L83X-A.01.14	To: Official After Sales Network Subject: Installation Of Rubber Boot Onto Alternator Date: 07 th /02/14 Pages: 3	
---------------------	-------------------------------------------------------------------------------------------------------------------------------------------------------------------	-------------------------------------------------------------------------------------

Subject
Installation of rubber boot onto alternator.

Model
All Lamborghini Model Aventador MY 12, 13 and 14 Coupe And Roadster from VIN CLA00091 to VIN ELA02542.

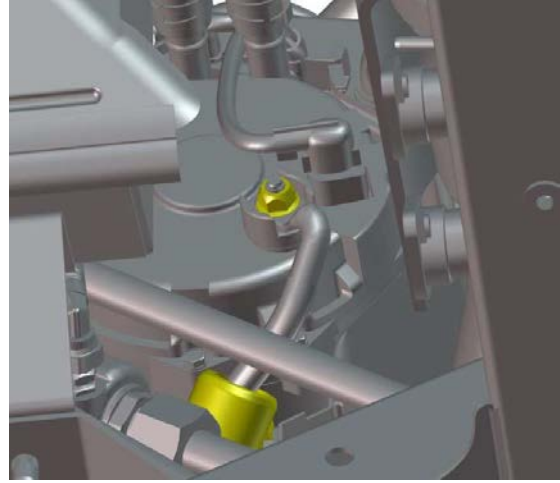
6. Remove nut that secure alternator positive cable.

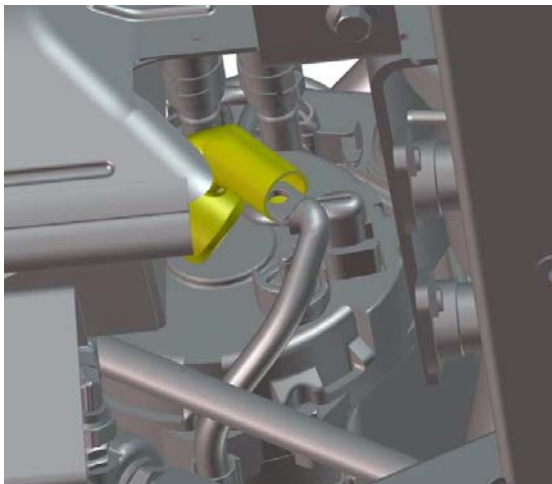
7. Fit rubber hood.

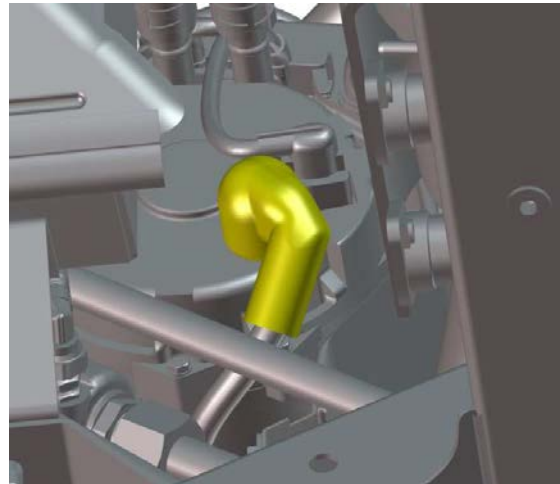
9. Let rubber cup fit well with nut as shown

8. Place correctly the cable and fasten the nut

Apply on nut protective wax AKR 392 110 21
EIW

Torque: 20 Nm
